February 8, 2016

Subject: Consent Agreement  
LADWP BR RTP Crossing #51-6 to 52-1  
Barren Ridge S.S. to Haskell S.S. T.L. R/W  
Midway-Vincent 500kV #1 & 2  
APN 3243-001-31/SCE File No. CON203053371

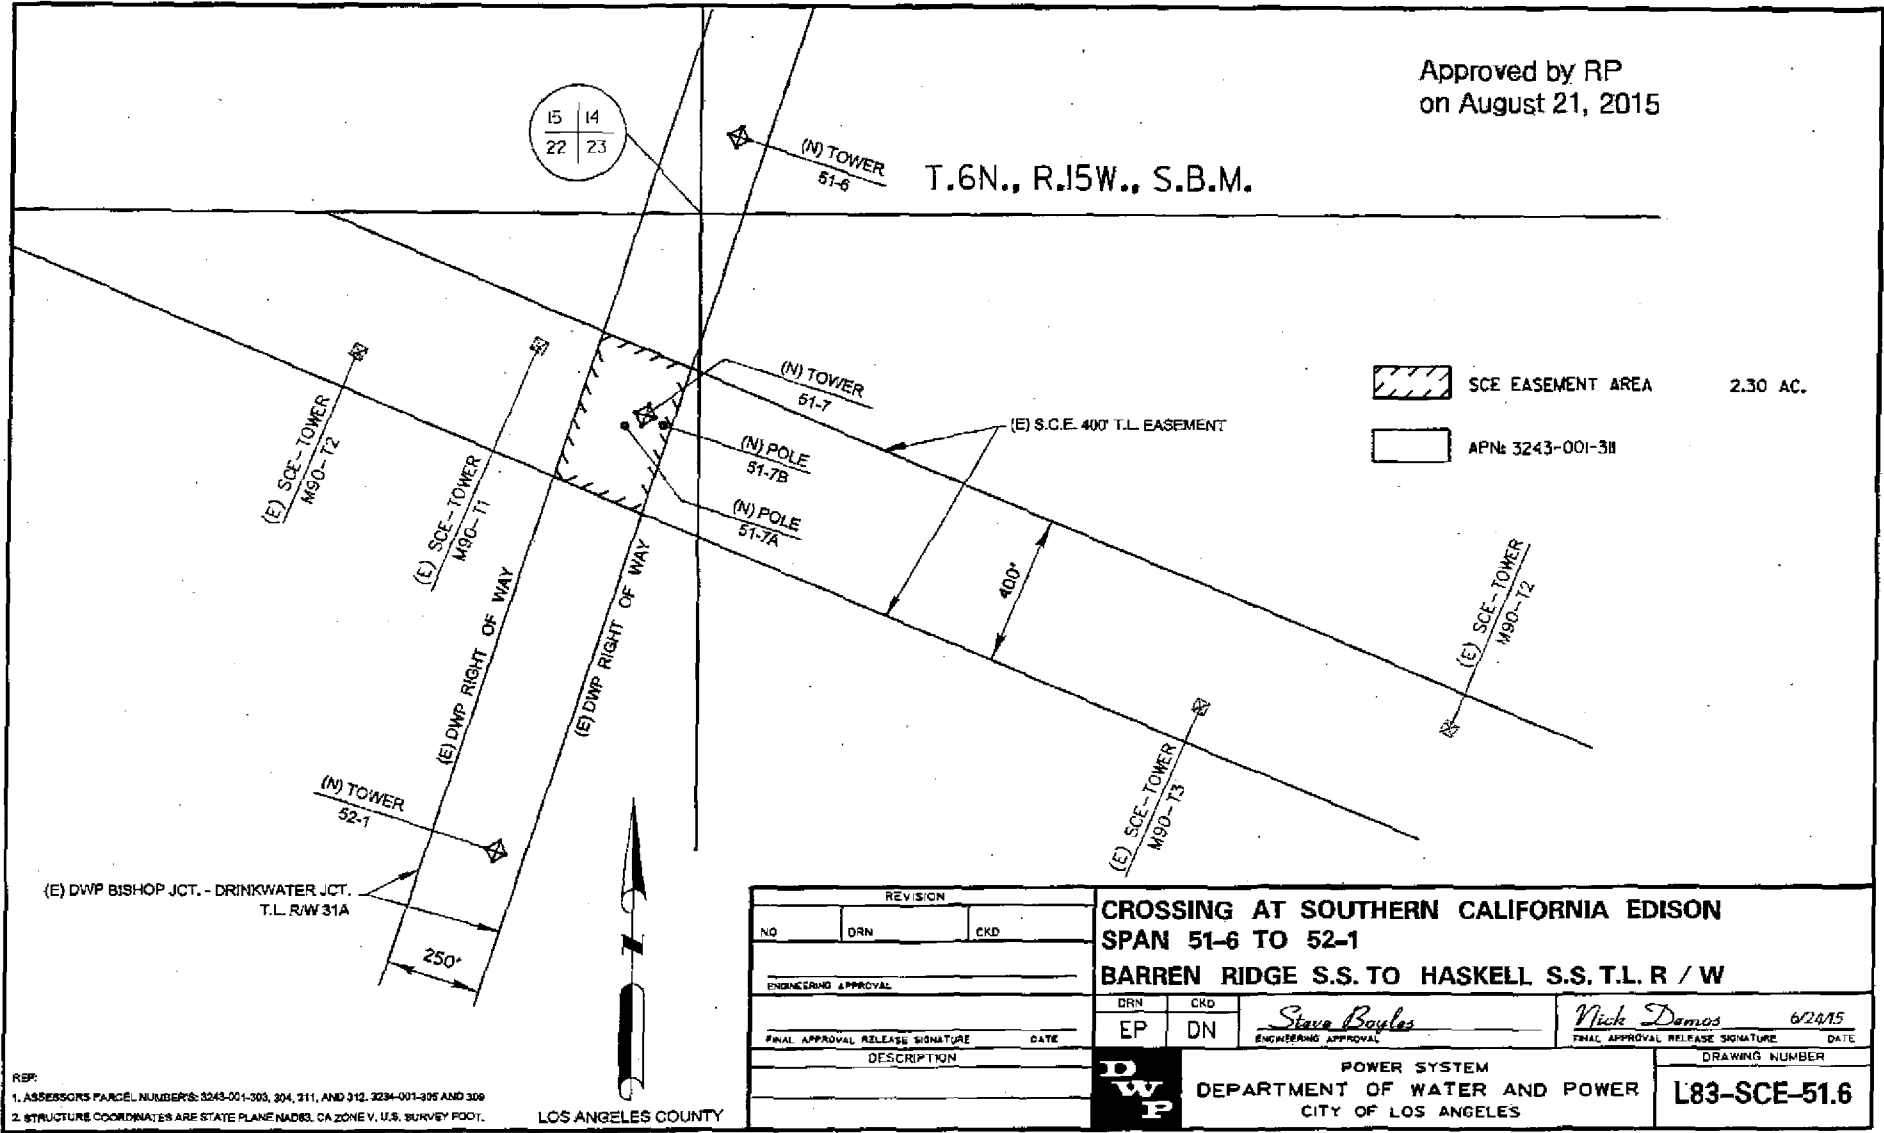
Southern California Edison Company (SCE) has reviewed and approved your request for the Los Angeles Department of Water & Power (LADWP) to cross SCE's Midway-Vincent 500kV #1 & 2 lines as shown on the attached plans entitled "Crossing at Southern California Edison Span 51-6 to 52-1, Barren Ridge S.S to Haskell S.S T.L. R/W", drawing number L83-SCE-51.6, sheet 1 of 1, final approval release date 6/24/2015, date stamped approved by RP on August 21, 2015.

5. It must be emphasized that these conditions are given from a review of conceptual/proposed plans, dated as shown, and submitted by LADWP. Any changes in the final plans may impose further review and further conditions to this agreement.
